**WKA9 - Retrofitting Warning Sticker on Emergency Release Handle for Slide/Tilt Sunroof (Stop Delivery)**

Vehicle Type: **911 Carrera S (992)/911 Carrera 4S (992)**

Subject: **Emergency operation of slide/tilt sunroof**

*Emergency release handle*

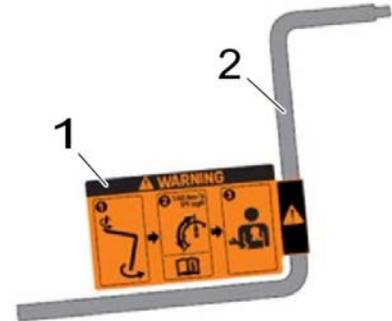
- 2 Remove plastic cover ⇒ *Emergency release handle -1-* and take emergency release handle ⇒ *Emergency release handle -2-* out of the tool kit.
